Technical Service Information

THM 200C

NO CONVERTER CLUTCH APPLY, OR HARSH CONVERTER CLUTCH APPLY

Figure 1

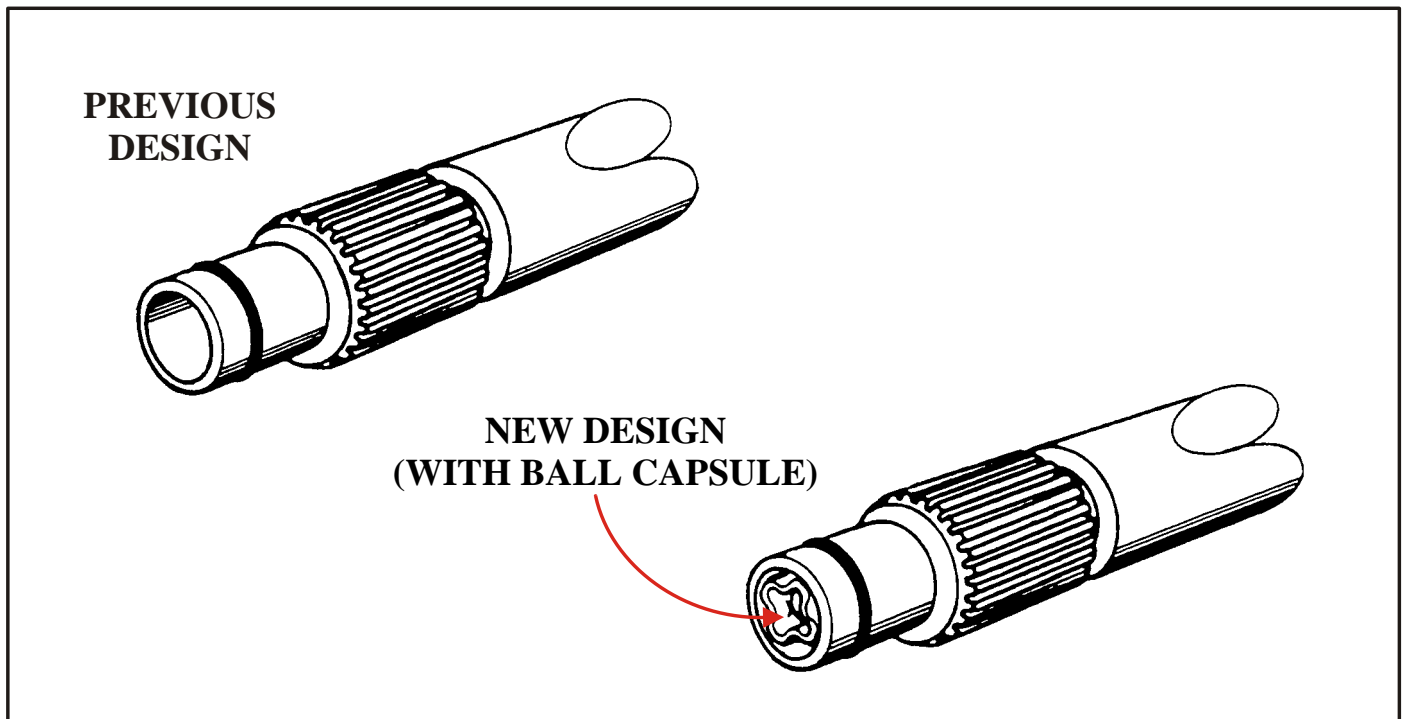
CHANGE: Beginning on October 8, 1986 (Julian Date 281), a new design turbine shaft that incorporates a ball capsule to cushion converter clutch apply, was introduced on ALL 1987 model THM 200C transmissions, as shown in Figure 1.

Figure 2

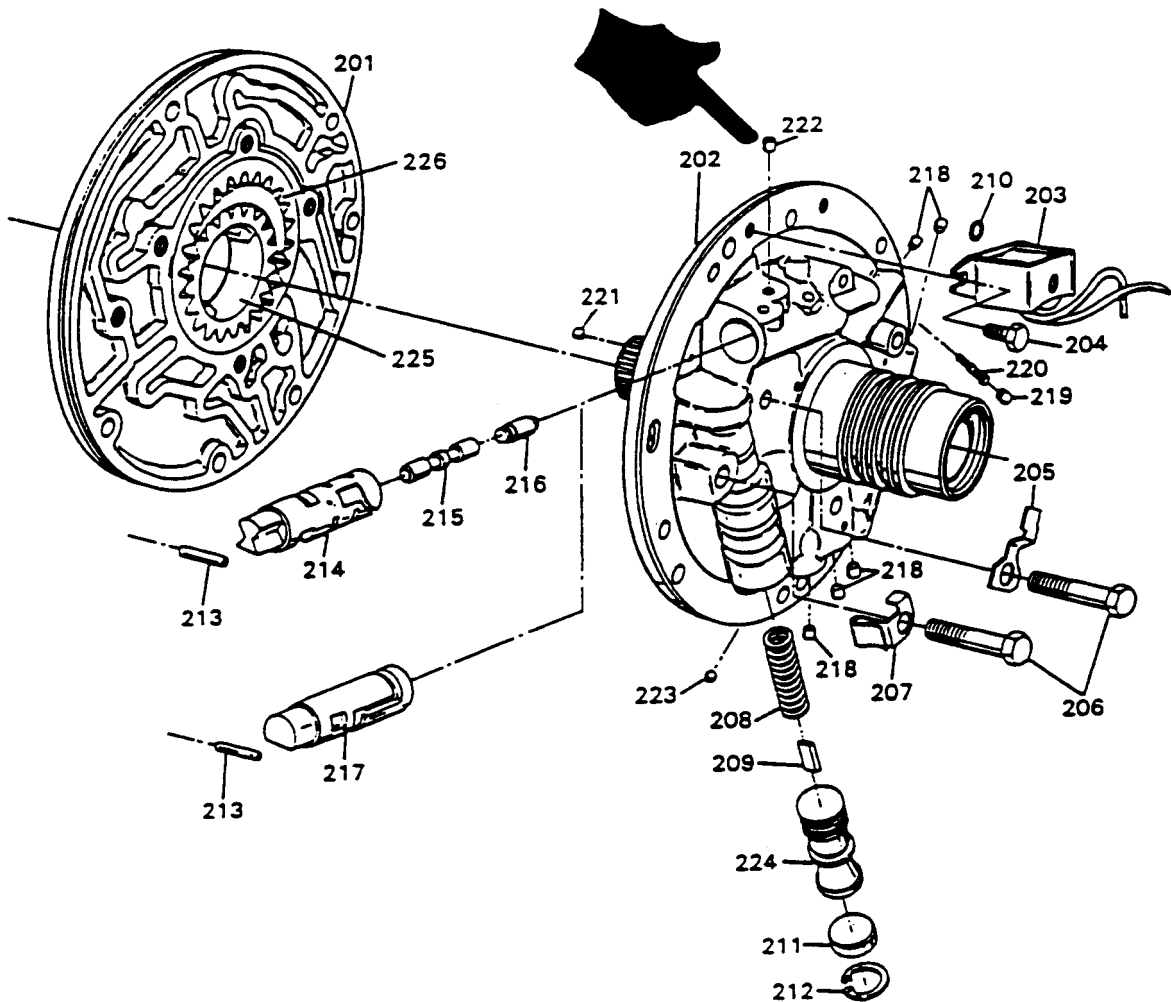
This change made it necessary to remove the orifice cup plug (222), shown in Figure 2, that was used to cushion converter clutch apply on ALL PREVIOUS model THM 200C transmissions.

(1) If you are using the new design turbine shaft with the ball capsule, the orifice cup plug (222) shown in Figure 2, **MUST BE REMOVED**. IF YOU INSTALL THE NEW DESIGN TURBINE SHAFT WITH ORIFICE CUP PLUG (222) IN THE TRANSMISSION, NO CONVERTER CLUTCH OR EXTREMELY LATE CONVERTER CLUTCH WILL BE THE COMPLAINT.

(2) If you are using the previous turbine shaft without the ball capsule, the orifice cup plug (222) shown in Figure 2, **MUST BE PRESENT**. IF YOU INSTALL THE PREVIOUS DESIGN TURBINE SHAFT WITHOUT ORIFICE CUP PLUG (222) IN THE TRANSMISSION, HARSH CONVERTER CLUTCH APPLY WILL BE THE COMPLAINT.
